TOWN OF WELLINGTON PLANNING COMMISSION June 2, 2025 6:30 PM

Final Plat for Wellington Business Center, Lots 7 & 8

Subject: Review of Amended Site Development Plans for Lots 1 and 2, Block 2, Bonfire Subdivision

Amended Site Development Plan for Kaufman & Robinson Inc.

CERTIFICATE OF OWNERSHIP

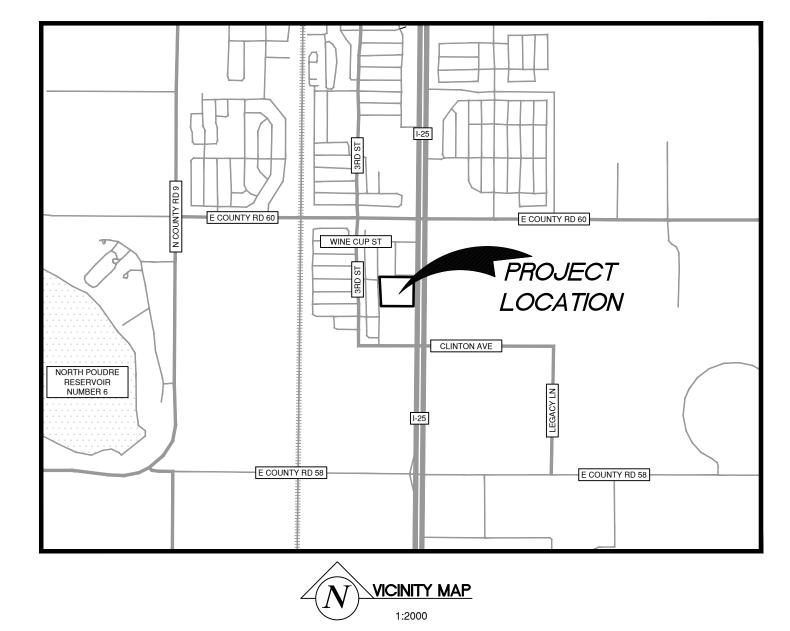
- Text amendments are needed on the Ownership Certificate to reflect appropriate business entity names and signature authorities, and to remove a duplicate Attorney Certification. Names and Titles of Town signatures are also requested to be included below signature lines on the Final Plat.

SOUTH EAST AEREAL 3D VIEW (FOR REFERENCE ONLY)

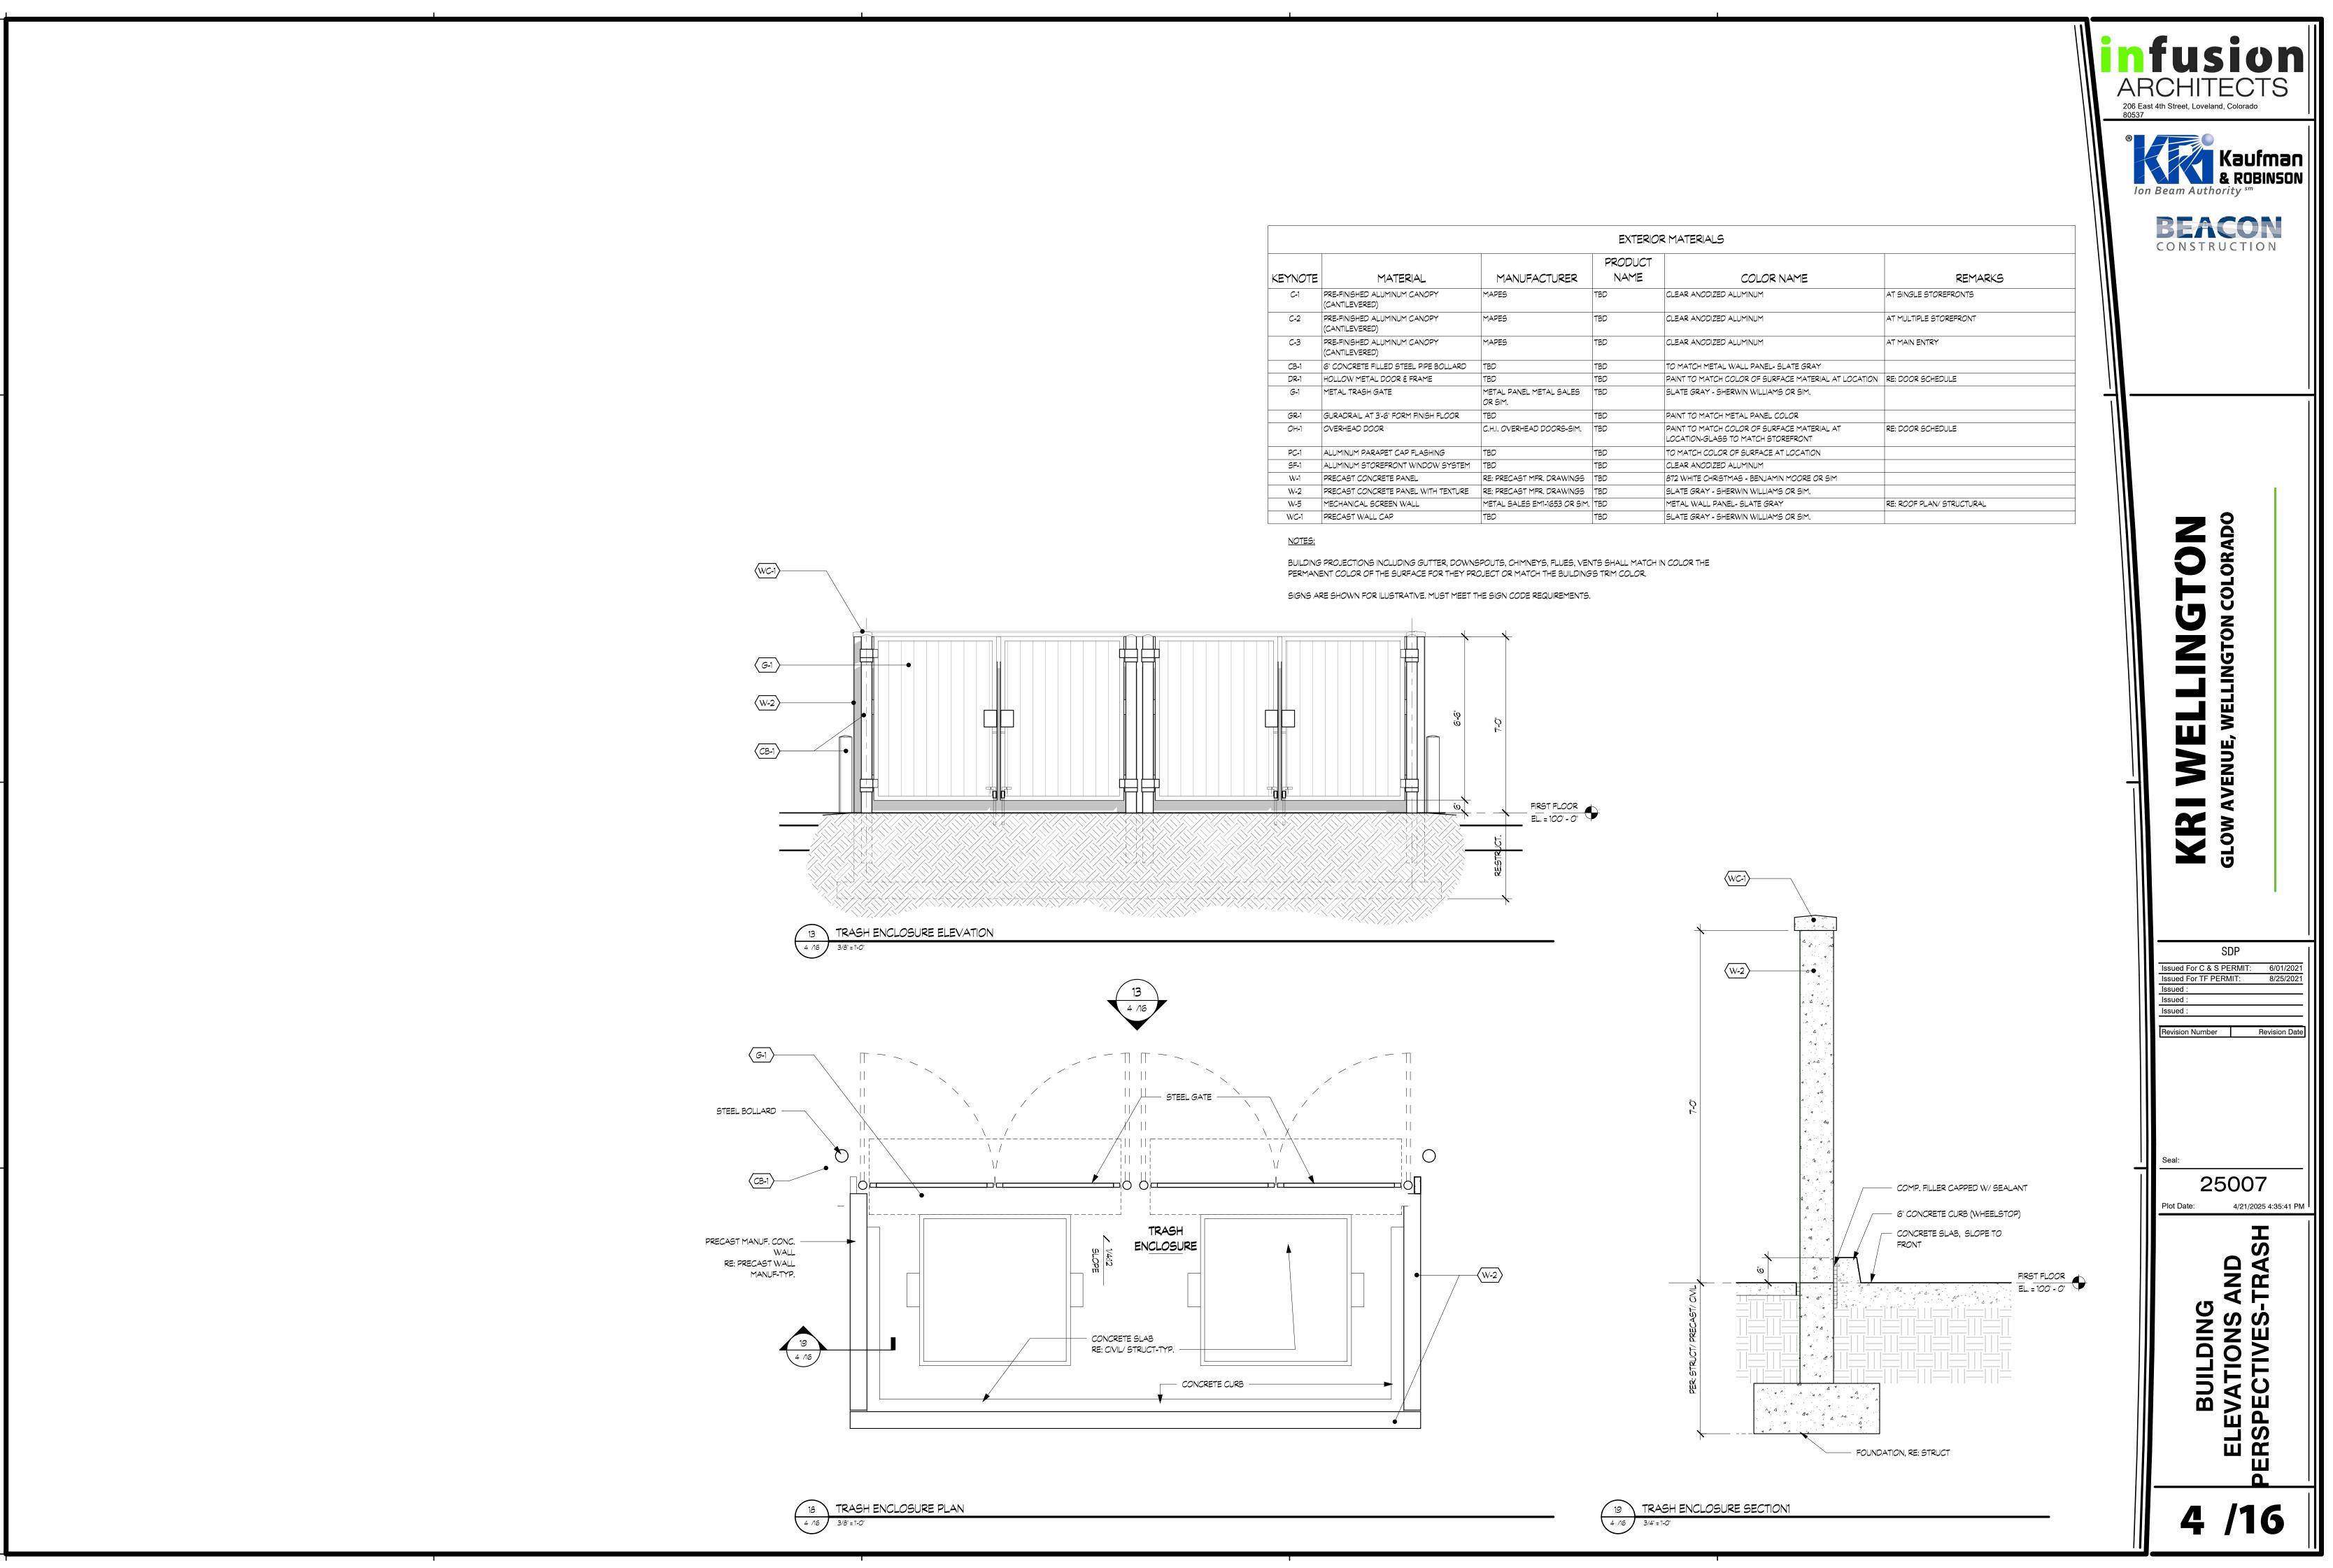
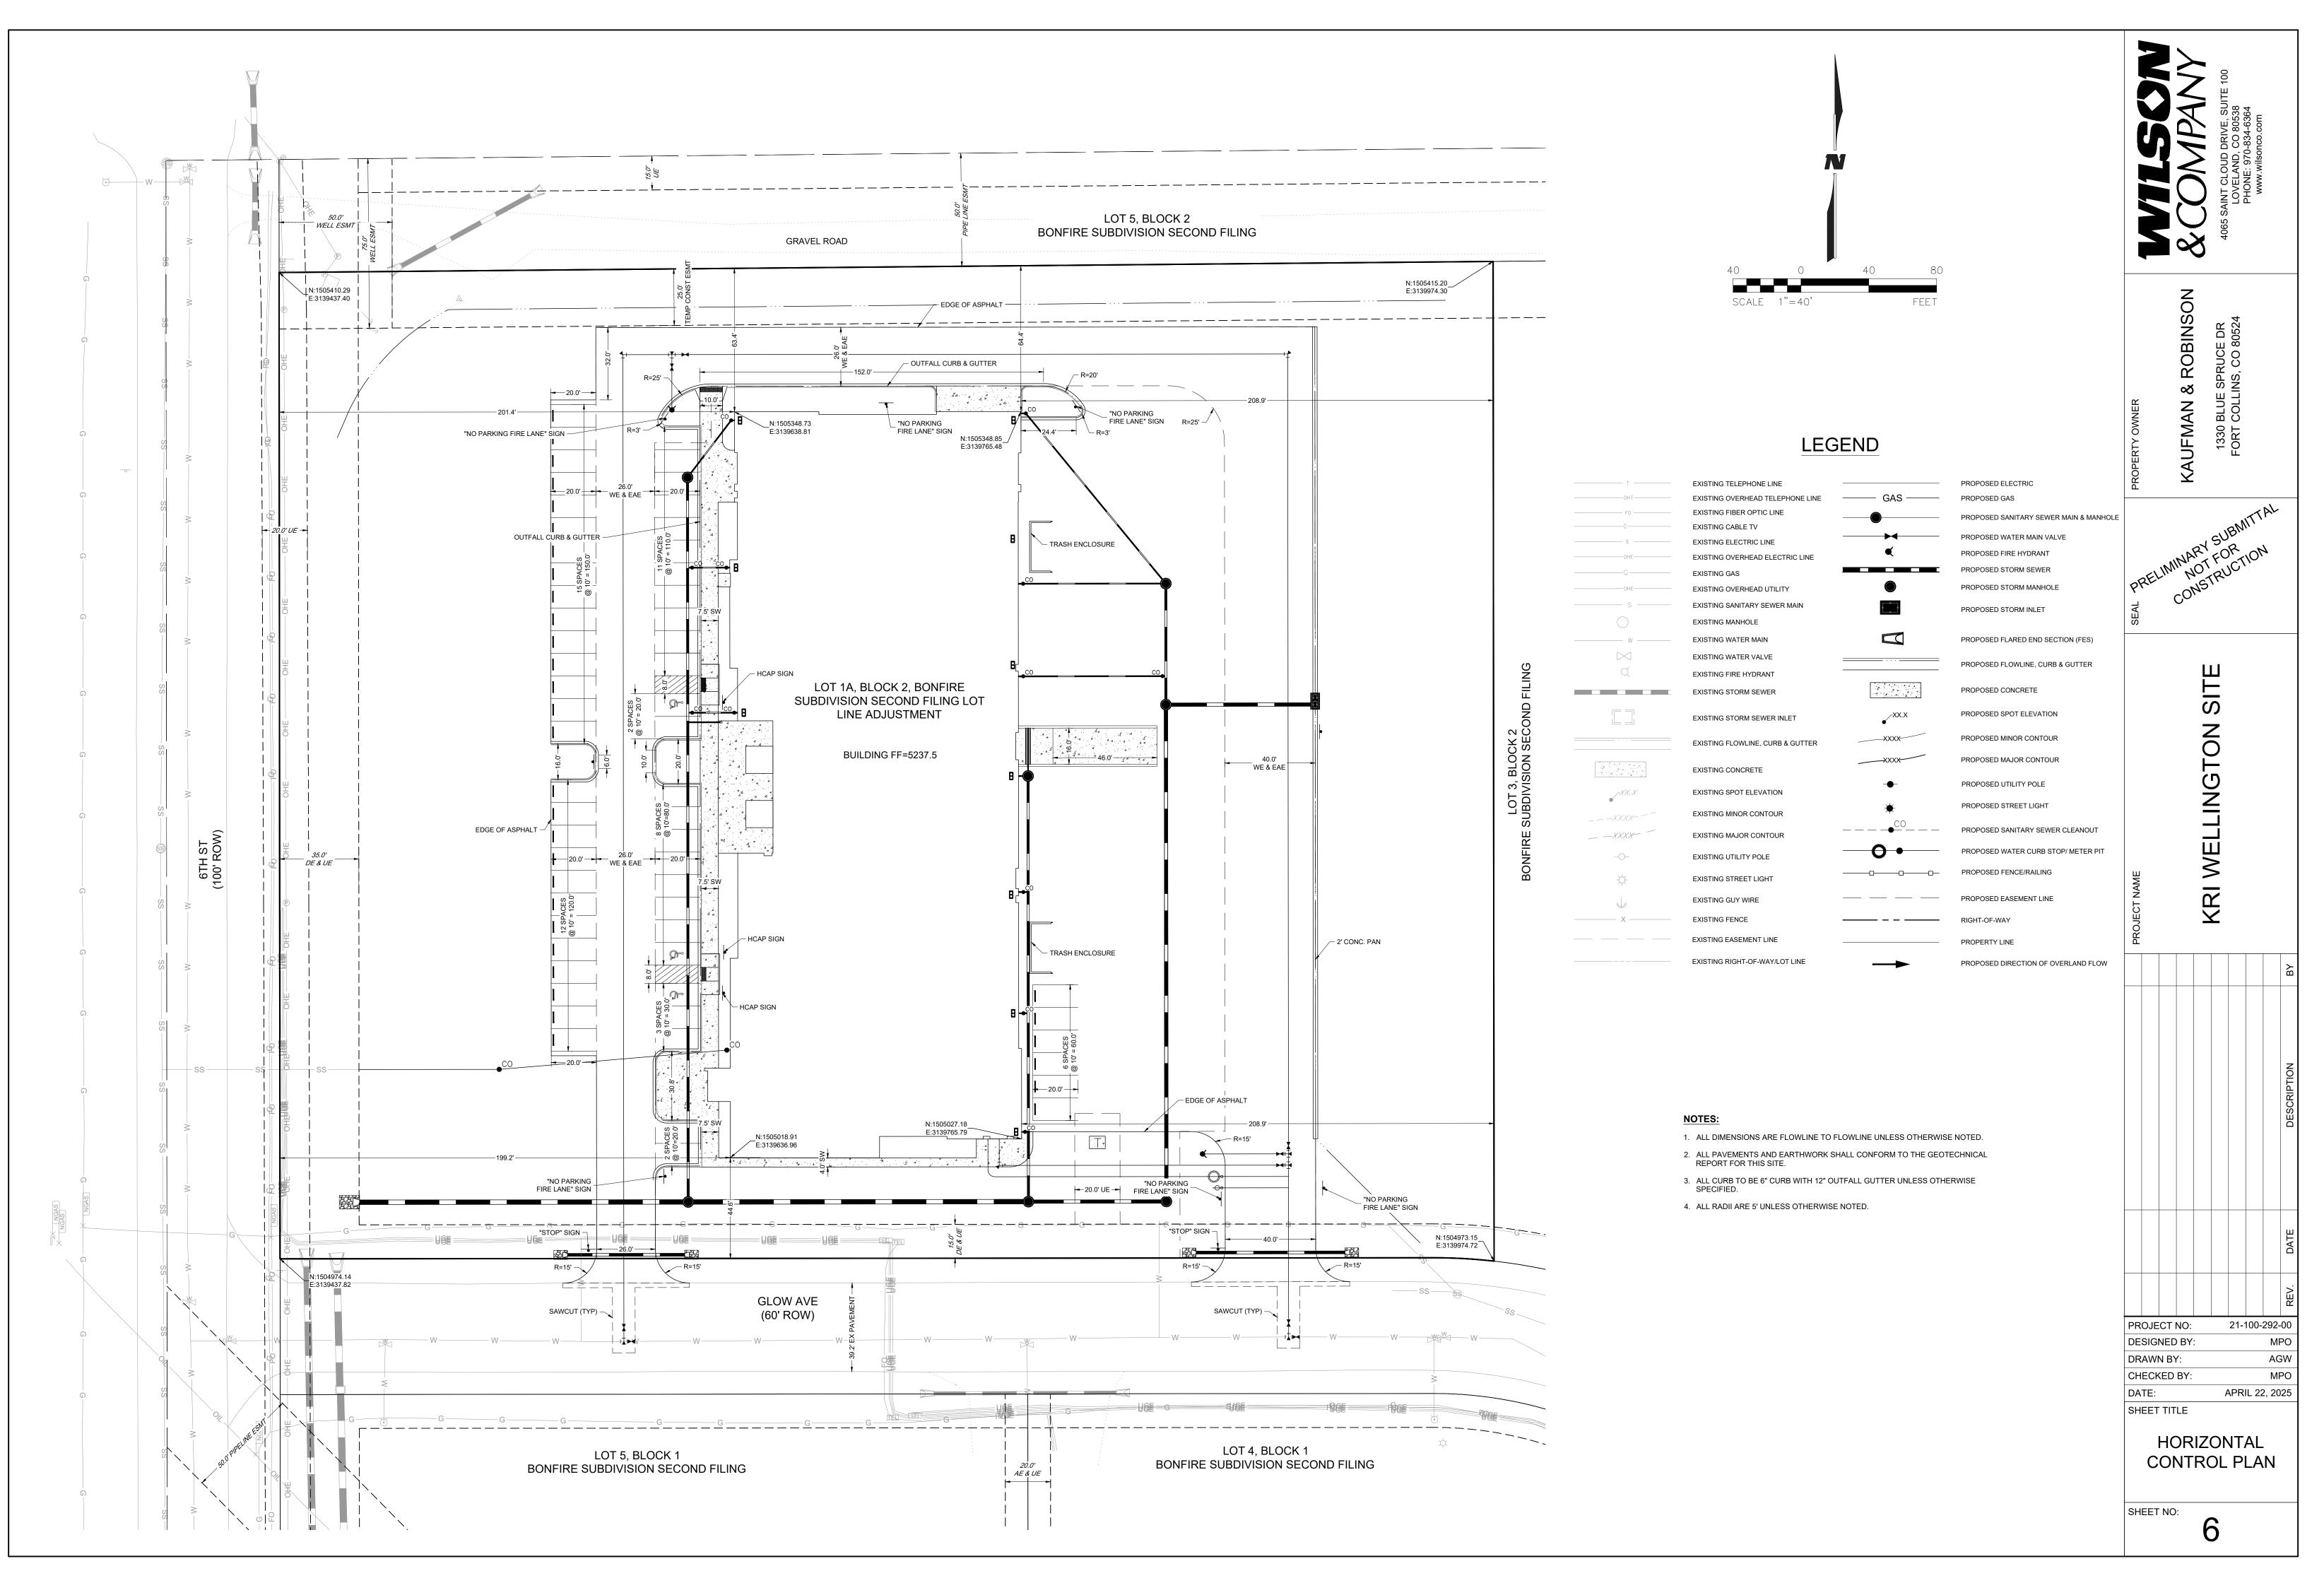
- The applicant is proposing to increase the building height from 28 ft. for the prior approval to 37 ft. The height increase exceeds 10% that can be approved administratively, and requires review by the Planning Commission.

- o The height of the building was increased to 37 feet. It is less than the district maximum of 45 feet.
- There were minor changes to the building layout (orientation and location of doors, a slight change to the building footprint). The building itself is not proposed to change in size.
